AIRWORTHINESS GROUP CHAIRMAN'S ERRATA AND ADDENDUM

- A. **ACCIDENT:** DCA08MA076
- LOCATIONS:** San Francisco International Airport, California
- DATE/TIME:** June 28, 2008, approximately 10:15 pm local time
- AIRCRAFT:** Boeing 767-281SF, N799AX

Number: 767-35A0034
Date: September 2, 1999
Revision 1: June 22, 2000
ATA System: 3510

SUBJECT: OXYGEN - Crew Oxygen - Crew Oxygen System Low Pressure Flex Hose Replacement

FIGURE 1. OXYGEN BOX HOSE TYPICAL LOCATIONS

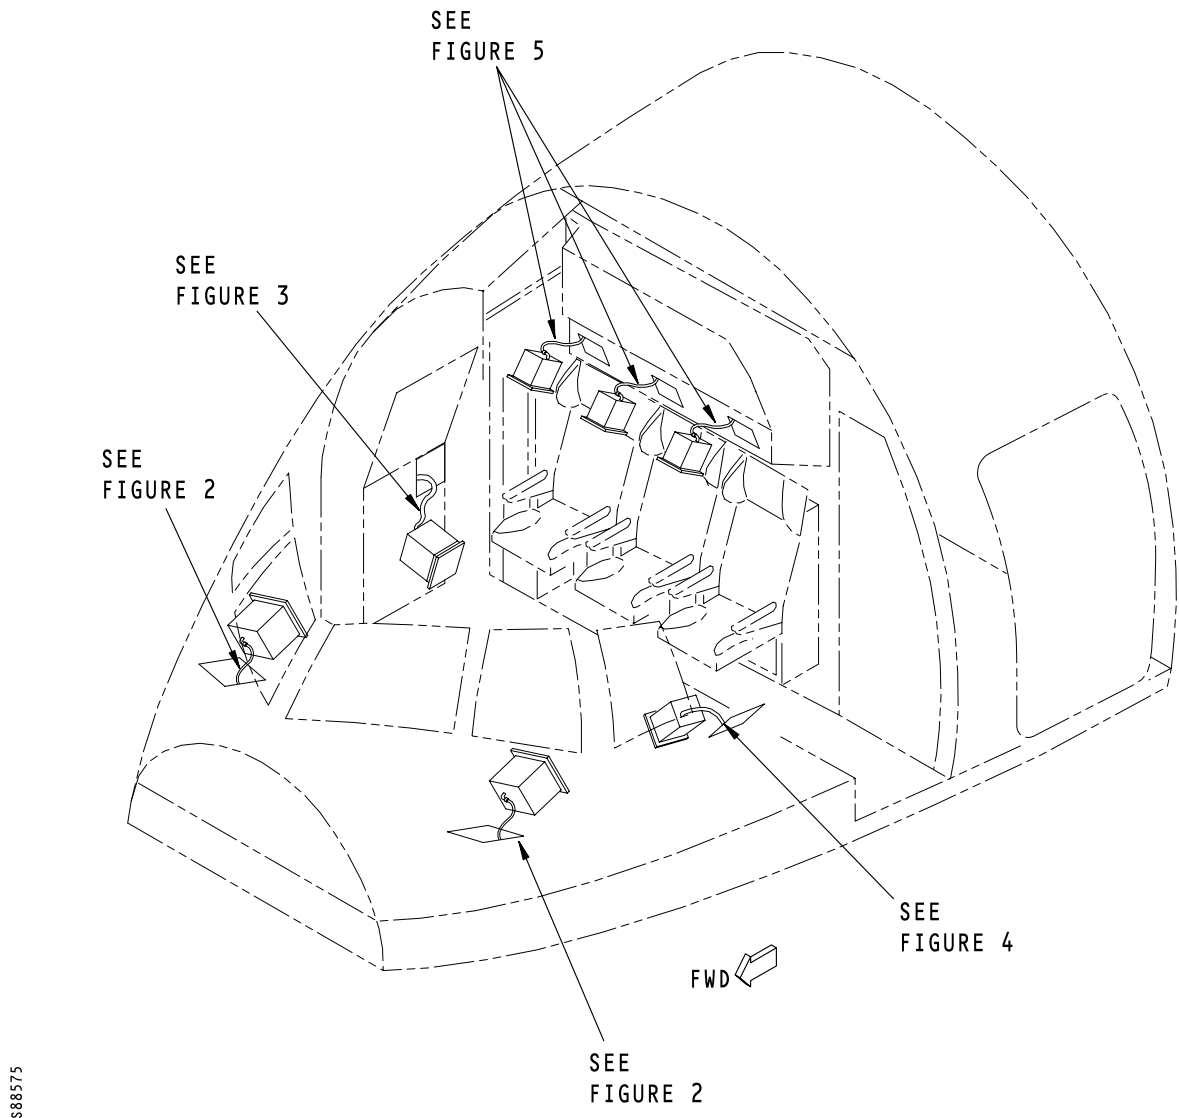
B. Remove the existing low pressure oxygen hoses as shown in Figures 1, 2, 3, 4, and 5.

E. Install the applicable new non-conductive oxygen hoses as shown in Figures 1, 2, 3, 4, and 5.

FIGURE 2. CAPTAIN AND FIRST OFFICER'S OXYGEN BOX HOSE REPLACEMENT

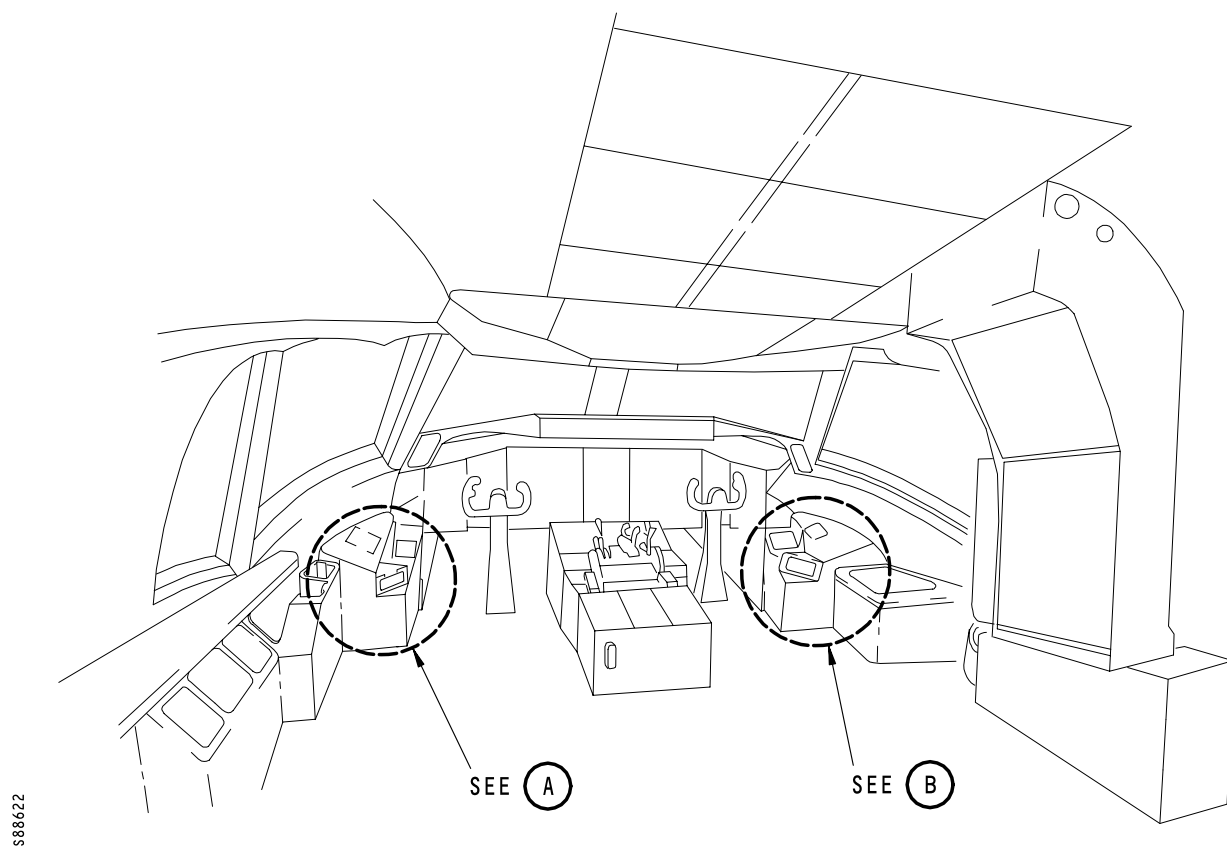
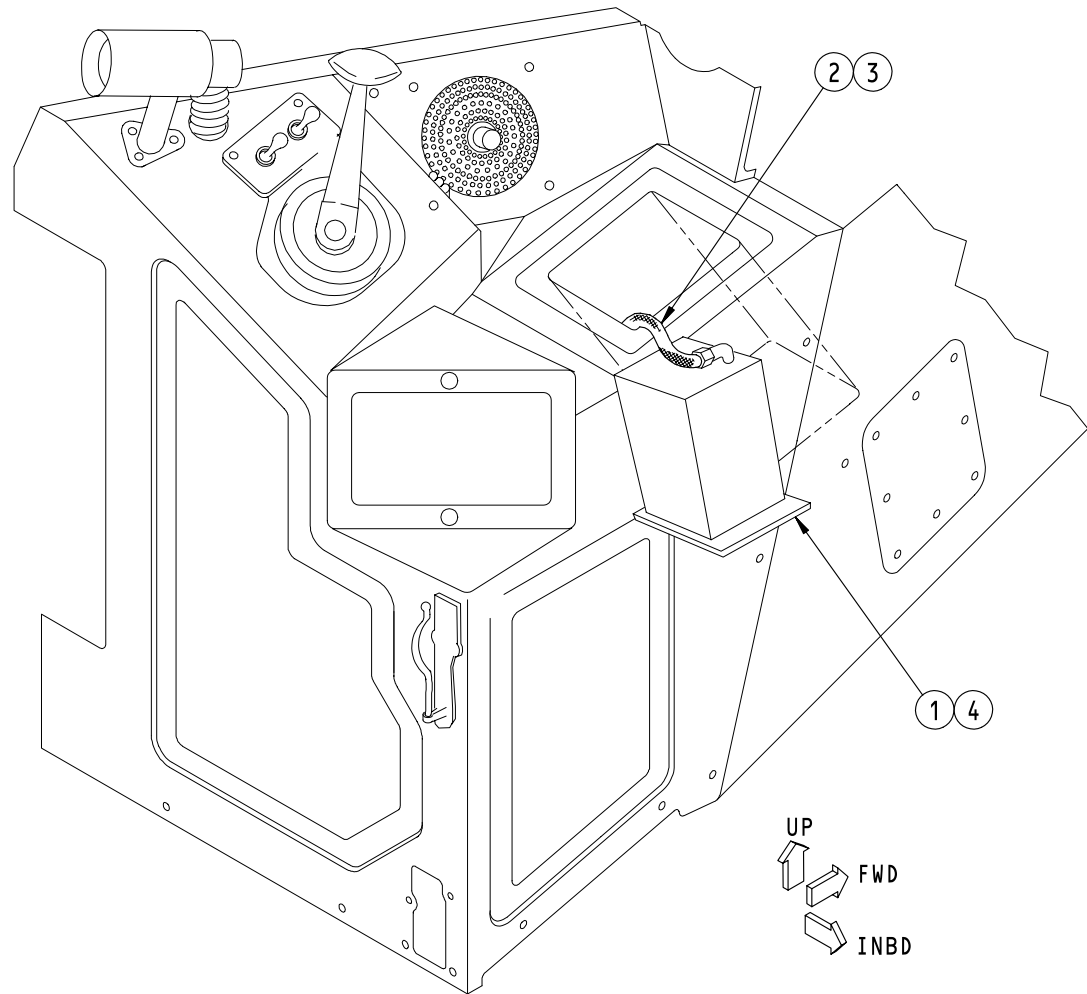
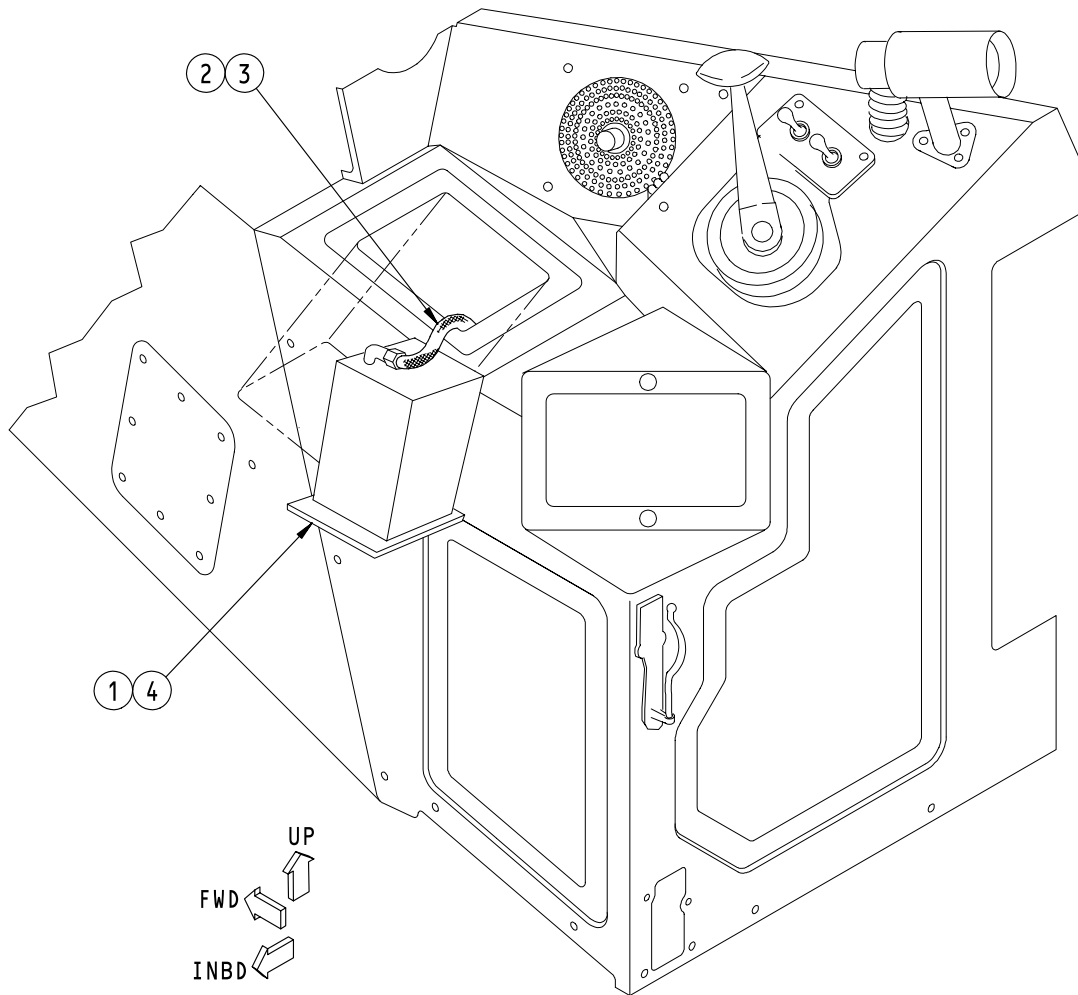
STEP	TASK	NAME	REFERENCES	QTY	NOTES
1	Remove / Keep	Oxygen Box	767 AMM 35-11-51	2	-
2	Remove / Discard	Hose Assy	767 AMM 35-11-51	2	Discard the Hose Assy after recording the part number.
3	Install	Hose Assy	767 AMM 35-11-51	2	See Existing Parts Accountability for applicable new Hose Assy.
4	Install / Kept	Oxygen Box	767 AMM 35-11-51	2	-

FIGURE 3. RIGHT OBSERVER'S SEAT OXYGEN BOX HOSE REPLACEMENT

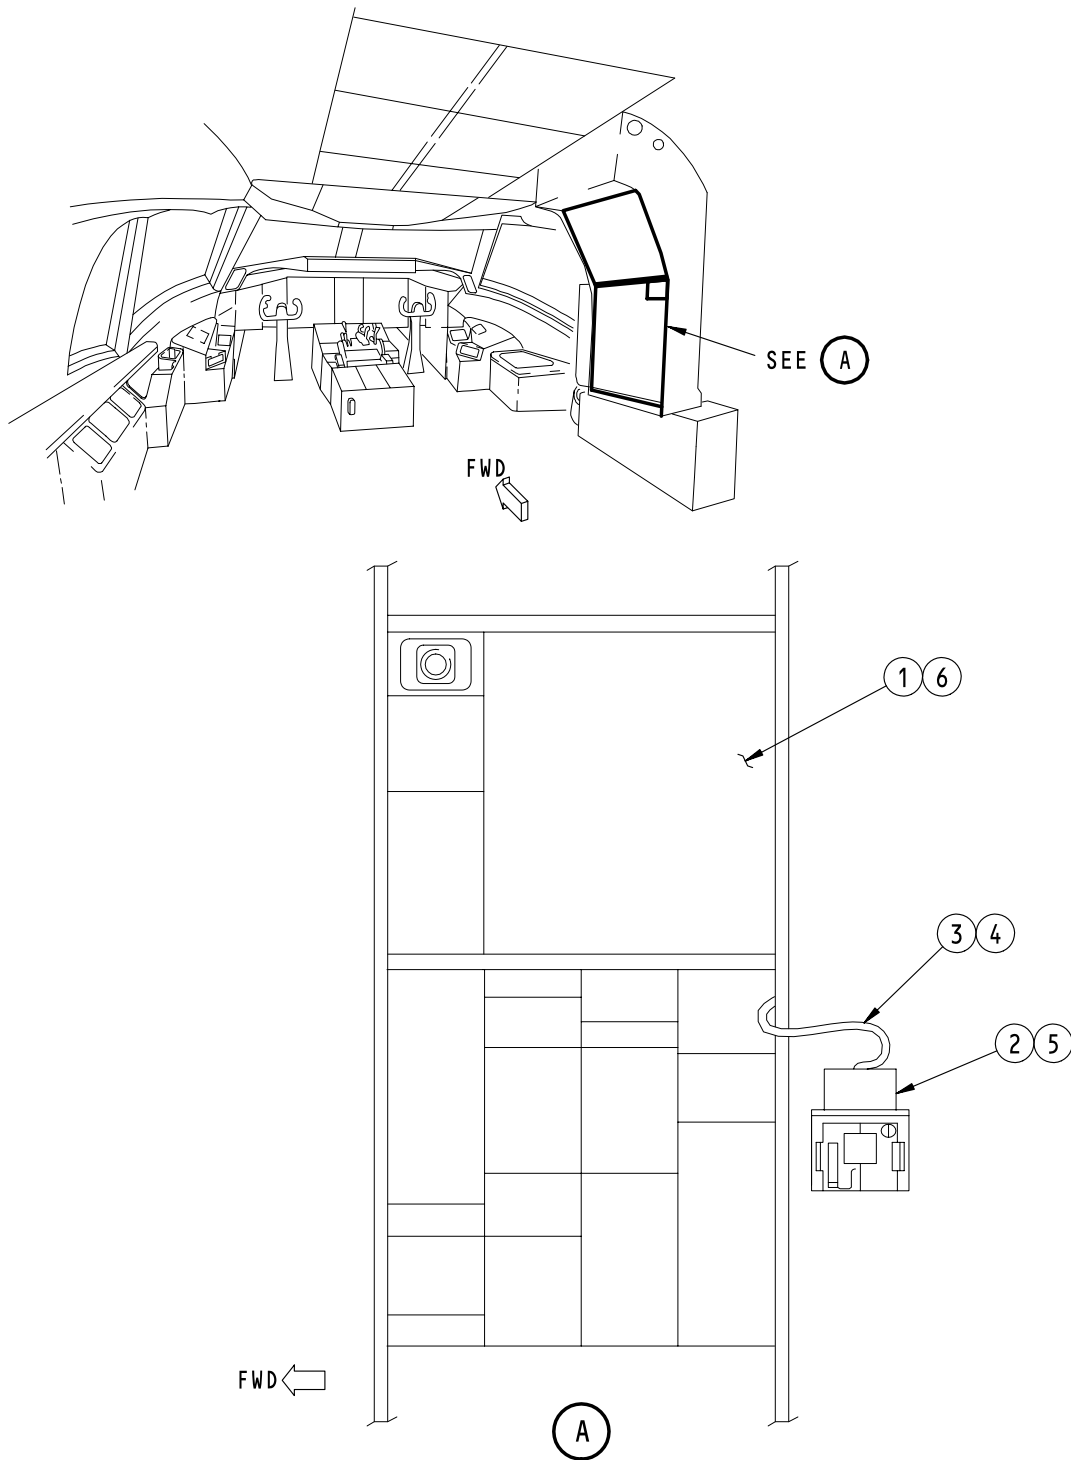
STEP	TASK	NAME	REFERENCES	QTY	NOTES
1	Remove / Keep	Blank Panel	-	1	-
2	Remove / Keep	Oxygen Box	767 AMM 35-11-51	1	-
3	Remove / Discard	Hose Assy	767 AMM 35-11-51	1	Discard the Hose Assy after recording the part number.
4	Install	Hose Assy	767 AMM 35-11-51	1	See Existing Parts Accountability for applicable new Hose Assy.
5	Install / Kept	Oxygen Box	767 AMM 35-11-51	1	-
6	Install / Kept	Blank Panel	-	1	-

FIGURE 4. LEFT OBSERVER'S SEAT OXYGEN BOX HOSE REPLACEMENT

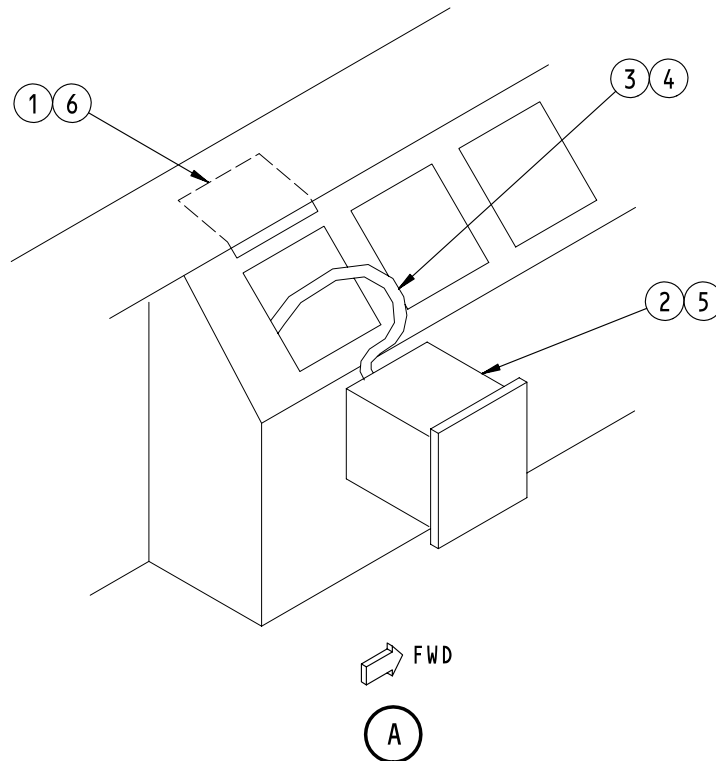
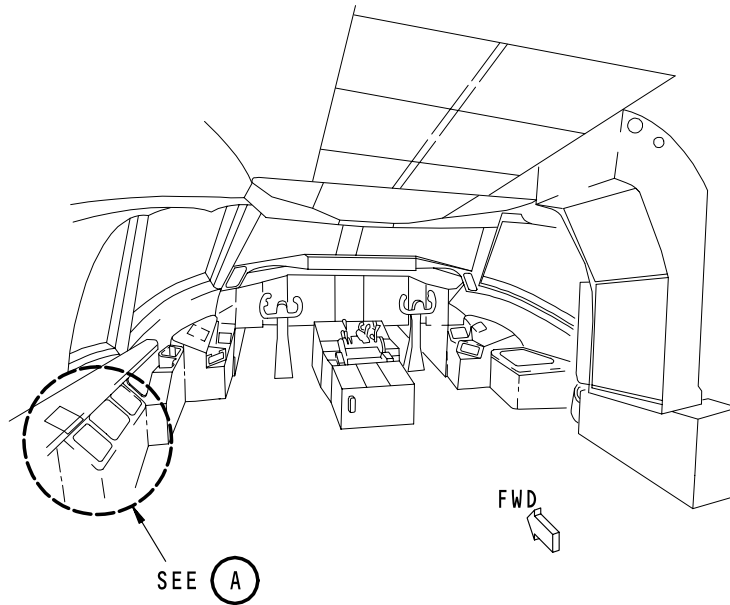
STEP	TASK	NAME	REFERENCES	QTY	NOTES
1	Remove / Keep	Panel	-	1	-
2	Remove / Keep	Oxygen Box	767 AMM 35-11-51	1	-
3	Remove / Discard	Hose Assy	767 AMM 35-11-51	1	Discard the Hose Assy after recording the part number.
4	Install	Hose Assy	767 AMM 35-11-51	1	See Existing Parts Accountability for the applicable new Hose Assy.
5	Install / Kept	Oxygen Box	767 AMM 35-11-51	1	-
6	Install / Kept	Panel	-	1	-

FIGURE 5. SUPERNUMERARY SEAT'S OXYGEN BOX HOSE REPLACEMENT

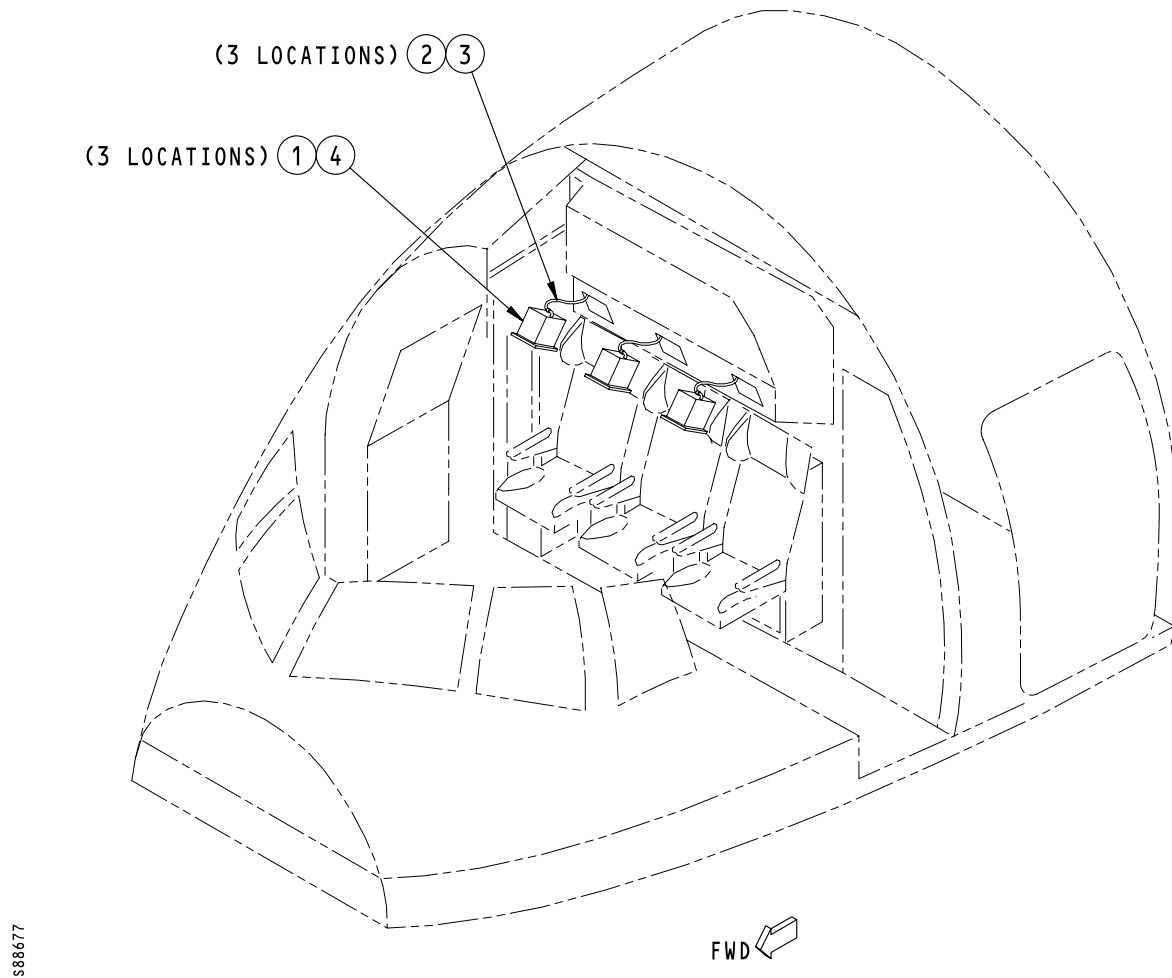
STEP	TASK	NAME	REFERENCES	QTY	NOTES
1	Remove / Keep	Oxygen Box	767 AMM 35-11-51	3	-
2	Remove / Discard	Hose Assy	767 AMM 35-11-51	4	Discard the Hose Assemblies after recording the part numbers.
3	Install	Hose Assy	767 AMM 35-11-51	4	See Existing Parts Accountability for the applicable new Hose Assy.
4	Install / Kept	Oxygen Box	767 AMM 35-11-51	3	-

FIGURE 6. SLEEVE INSTALLATION

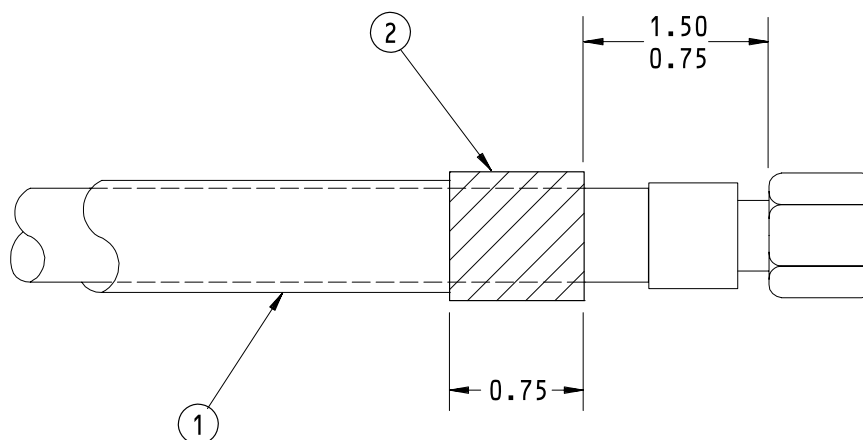
C. Install the sleeving on the captain and first officer's low pressure oxygen hoses as shown in Figure 6.

STEP	TASK	NAME	PART NUMBER	QTY	NOTES
1	Install	Sleeve	232T8002-100	2	-
2	Apply	Protective Tape	232T8002-26	AR	Permacel P29 on each end of the sleeving to prevent slipping.

FIGURE 7. TAPE APPLICATION

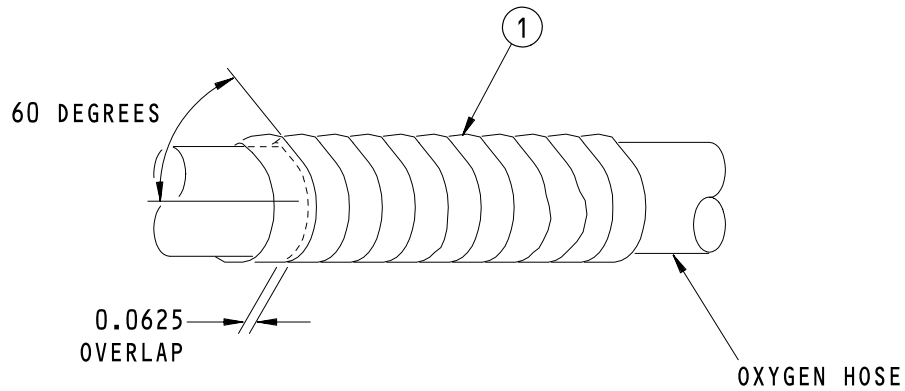
D. Apply protective tape to all other crew low pressure oxygen hoses as shown in Figure 7.

STEP	TASK	NAME	PART NUMBER	QTY	NOTES
1	Apply	Protective Tape	232T8002-26	AR	2 layers of Permacel P29 along the full length of the low pressure oxygen hoses in all locations except the captain and first officer's position.
